File SPR-1996-165

Name: Luxury Wheels – 629 Hollingsworth (2531 Blichmann)

Site Plan Review #SPR-96-165- Luxury Wheels
Foresight Industrial Park
Staff: Bill Nebeker 
July 23, 1996

FILE #SPR-96-165

AS-BUILT LANDSCAPE AND SITE PLAN
 SCALE: 1"=20'-0"

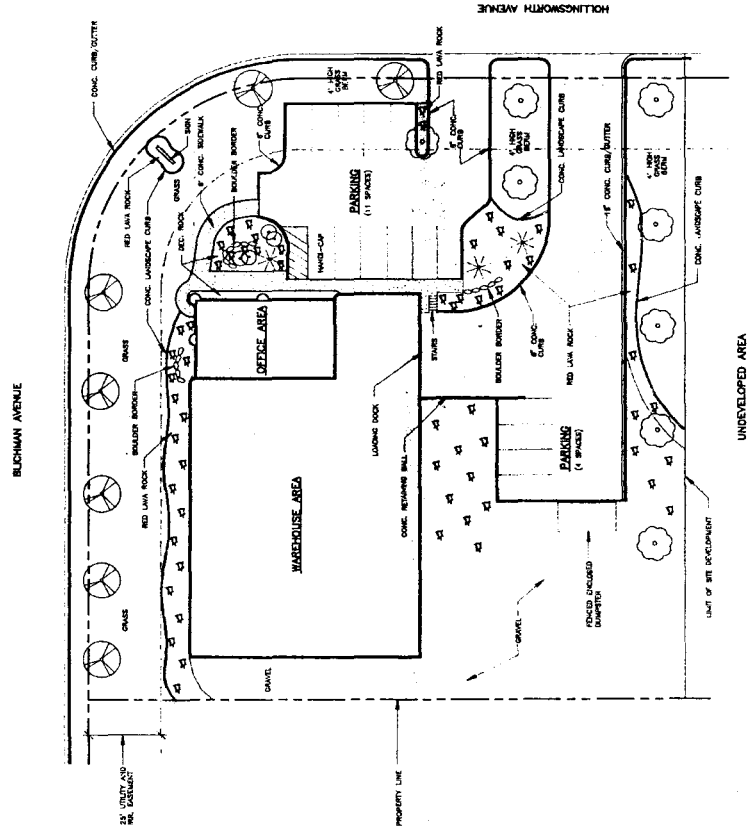
The project file for Luxury Wheels has not been completed. The building has been in operation for over six months without a certificate of occupancy (C of O) from the Mesa County Building Department. The C of O cannot be signed by our department because the site was not built in accordance with the approved site plan dated August 5, 1996. Among some of the changes to the as-built site are fewer trees planted and less parking stalls constructed. Also the monument sign in front of the building was constructed without a sign permit.

Comments: Original site plan approved August 5, 1997. Site not built as shown on the site plan - changes in # of parking spaces and landscaping. Revised as-built plan submitted and approved on November 19, 1997.

- 1) Sign Permit - I have contacted Bud's Signs.
- 2) Revise Landscape Design - I will have Rob Rowllins revise the landscape design per your request.
- 3) Explain Parking Revision - Our maximum # of employees is 10.

Rob Rowlands from PA\DS Architects submitted the revised as-built site plan for your facility in the Foresight Business Park. The new plan is approved and I've enclosed a copy of it with our approval stamp for your records. I've also submitted a copy of the Certificate of Occupancy and sent the original to the Building Department. A sign permit will still be required for the monument sign in front of the property.

1 SITE PLAN

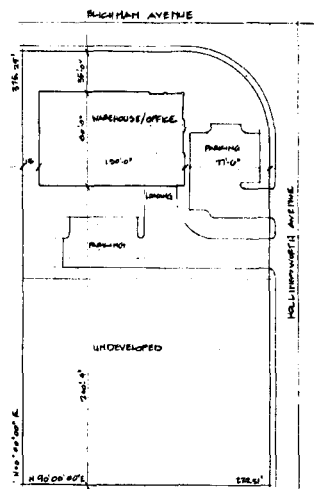
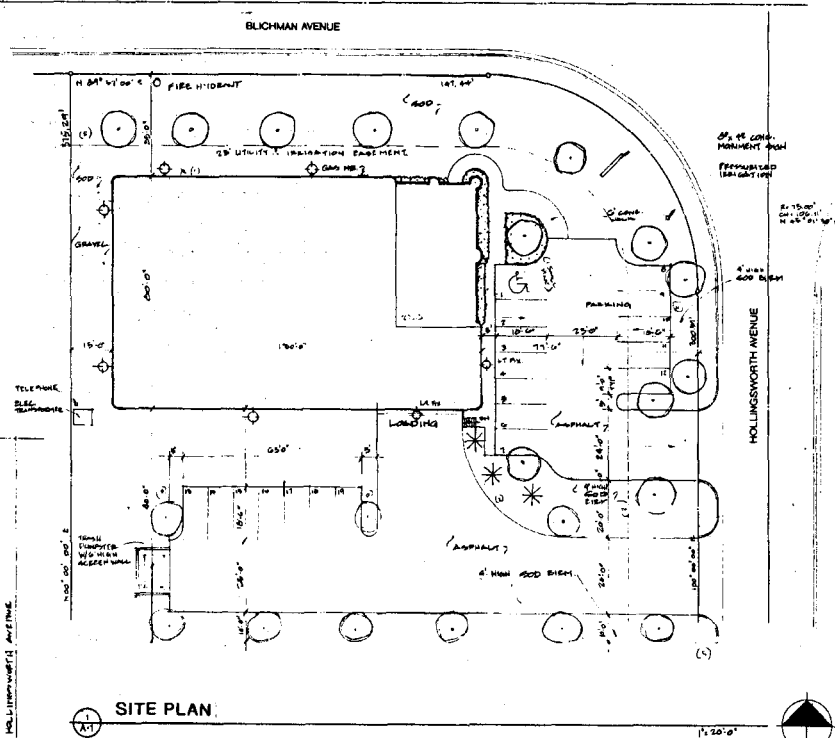
1. The following discrepancies were found between the site plan and the Foresight Park CC&Rs. Please correct accordingly:
 - a. CC&Rs require 35' front yard setbacks; site plan shows a 30' setback along Blichman Ave.

- b. Did the ACCO grant a variance to allow more than 20% of a front yard to be devoted to customer parking spaces? the site plan shows that more than 50% of the front yard setback along Hollingsworth Ave contains paved areas.

- c. CC&Rs and city code require all off-street parking, access and loading areas to be paved; site plan shows employee parking as graveled
 - d. CC&Rs require a maximum width of 26' per access point from the street to the building; site plan shows second driveway being 30' wide

2. How was the 32 required parking spaces calculated? All required parking must be paved.
3. Provide a typical dimension for parking. Provide widths for driveways.

4. One disabled parking space is required for each 25 spaces provided.

5. Does the loading dock include an elevated platform? Clarify use of stairs to east of loading dock. Show location of overhead doors and all entrance/exits to building.

6. What is the width of the sign?
7. Where is the 6' concrete walk noted on the site plan below the sign?
8. How far does the sod south of the asphalt loading area extend into the undeveloped area? the site plan is unclear.

9. Site plan shall include required note that an underground, pressurized irrigation system will be required for all landscaped areas.
10. Placement of shrubs appears to be a little skimpy. The CC&Rs require adequate screening of parking areas which is difficult with sod and trees only. There also appears to be an awful lot of gravel.

11. Change street name to Blichman Avenue.
12. Please submit a copy of all plans that were reviewed by the ACCO (site plan, if different from the plan submitted to our department; floor plan; elevation plan; drainage report, if different from that submitted; and memo dated July 10, 1996 from Burke construction which further explains the plans).

1. The site plan needs to show the entire parcel.
2. It appears the required parking is 35 spaces, not 32 spaces.
3. All required parking and maneuvering areas are required to be paved.
4. The drainage report will need to be revised based on the additional paved area. The City Code provides an option to pay a drainage fee in lieu of on-site detention. Based on the calculations presented in the drainage report, the fee will be more than \$5500. A more exact fee will be calculated with the revised report, unless on-site detention is selected. If detention is selected, the report must show all calculations and sizing of the detention facility and outlet works.
5. Transportation Capacity Payment is \$4160.00.
6. Two driveways side by side will not be allowed. A permit for a curb cut must be obtained from the City Engineer's office prior to construction.
